TX SNDR and R_{peak} limits for CR and C2M

Alexander Rysin and Piers Dawe, NVIDIA

SNDR Measurements

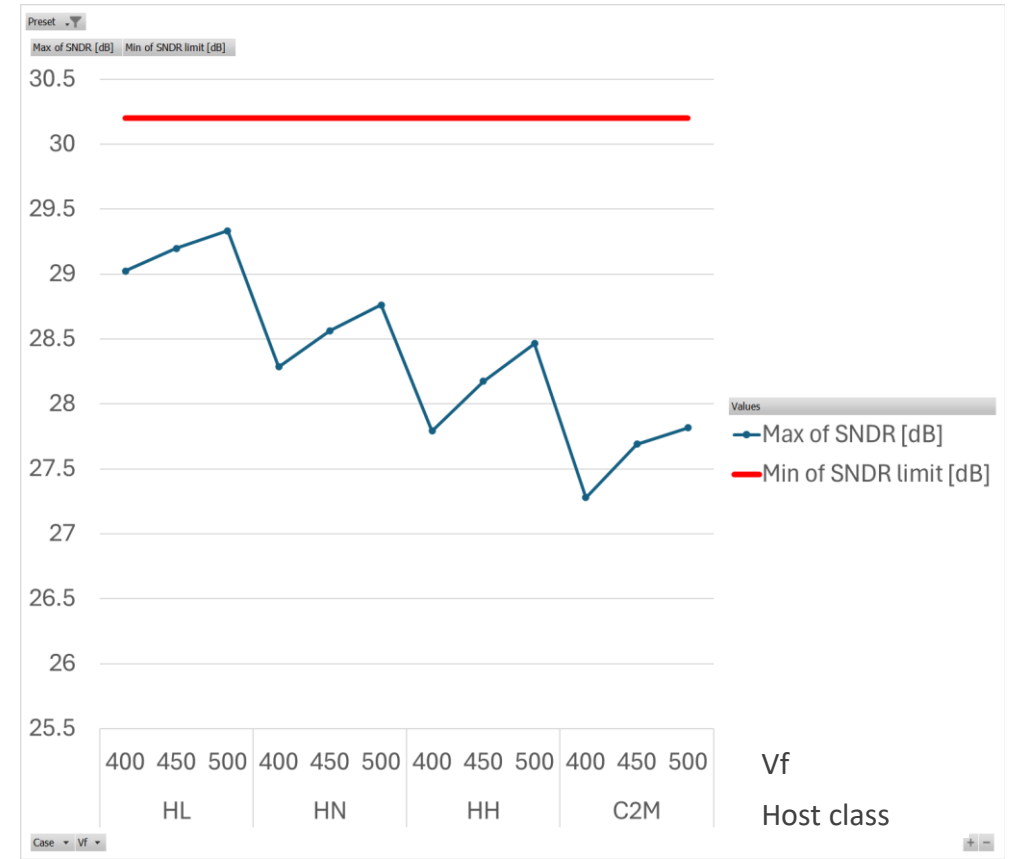
- The current limits for R_{peak} seem to be placeholders. When tested with an instrument-grade TX and practical host channels, these limits are marginal for HL and cannot be met for HN.
- Current limits for SNDR for most of the presets cannot be met even with instrument-grade TX and practical host channels.
- Currently the SNDR limits are the same for all CR and C2M host types. Measurements indicate a dependence of SNDR on the host loss and signal strength.
- Relates to comments 299 and 300.

- Adjust Rpeak limits in CL179 for HL and HN classes:
 - Rpeak for HL = 0.425
 - Rpeak for HN = 0.3
- Adjust the SNDR limits based on the lab data:

Preset	Current limit [dB]	Proposed limit [dB]
1	33.5	32
2	27.5	28
3	30.7	29.5
4	30.2	27
5	28.7	25.7
6 (initialize)	31	30
